LAKE ARTHUR, GRAND LAKE, AND GULF INTRACOASTAL WATERWAY TMDLS FOR DISSOLVED OXYGEN, NUTRIENTS, AND AMMONIA

SUBSEGMENTS 050402, 050701, 050602, AND 050702

US EPA Region 6
Water Quality Protection Division
Watershed Management Section

FTN Associates, Ltd.
3 Innwood Circle, Suite 220
Little Rock, AR 72211

Figure 3.1. Vector diagram for LA-QUAL model.

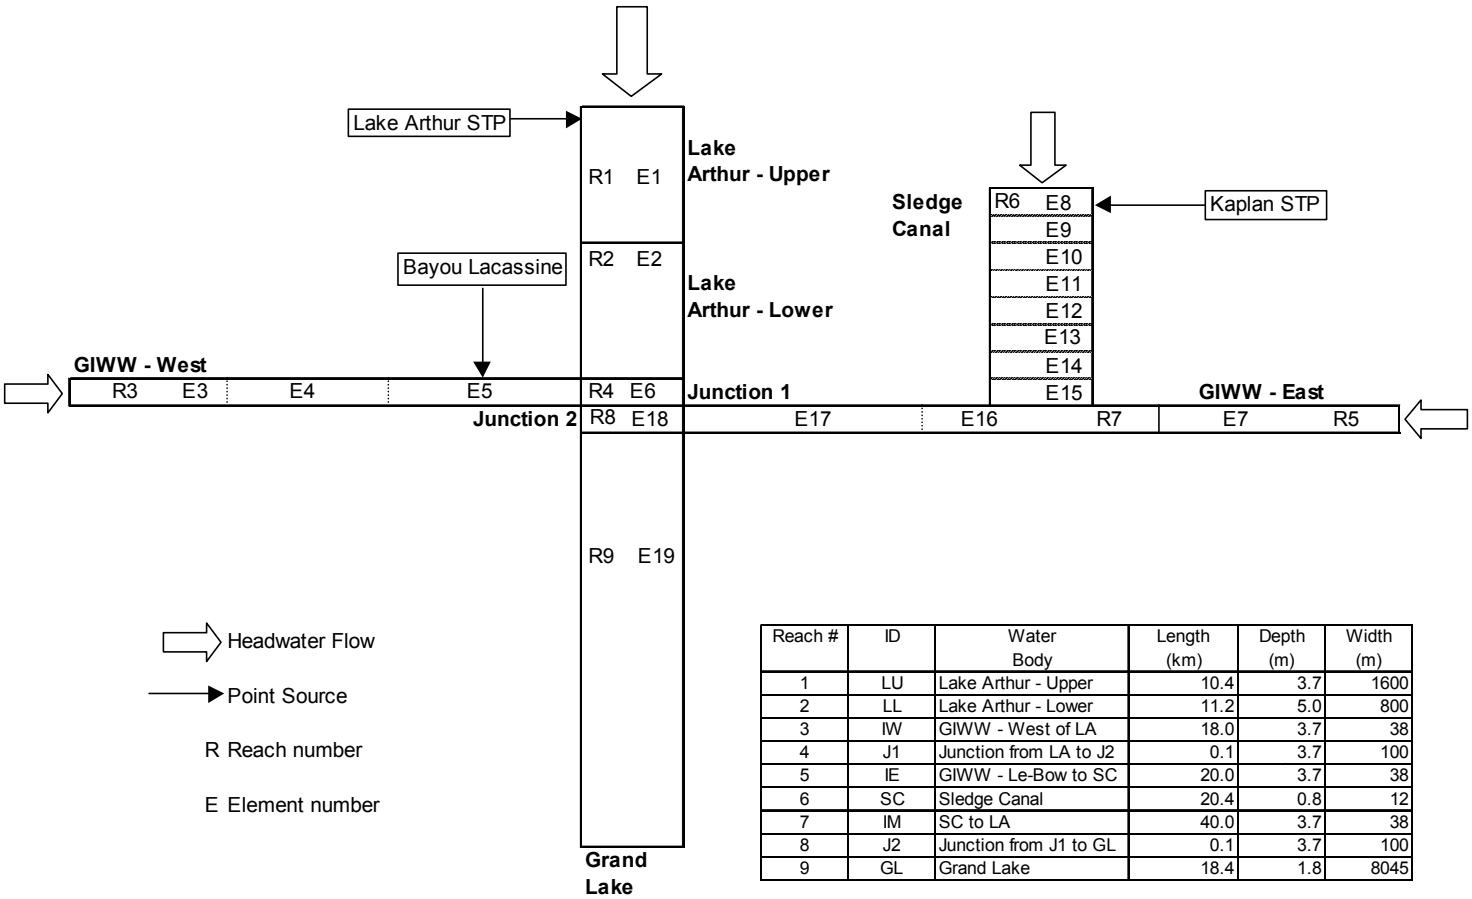
2. Figure 3.1, page 7: Certain reaches have discrepancies when compared to the calibration model input sets. Reach 8 is listed as "J2" in the figure and as "J3" in the model input. Reach 4's description does not correlate to any of the other two digit reach labels.

3. Figure 3.1, page 7: The width and length values listed in reach 9 could not be verified with the satellite imagery mapping available to LDEQ.

6. Figure 3.1, page 7: Certain reaches have discrepancies when compared to the calibration model input sets. Reach 8 is listed as "J2" in the figure and as "J3" in the model input. Reach 4's description does not correlate to any of the other two digit reach labels.

7. Figure 3.1, page 7: The listed width values do not match the actual widths in the calibration model output. The differentials are small, however, for consistency the values should match.

8. Figure 3.1, page 7: The width and length values listed in reach 9 could not be verified with the satellite imagery mapping available to LDEQ.

Response: The ID for reach 8 has been changed from J3 to J2 in the model. This has no effect on the model output.

Response: The width and length multiplied together yield a surface area of approximately 58 square miles, which appears to be correct.

Response: The differences are due to round-off when specifying velocity coefficients rather than width coefficients in data type 8.
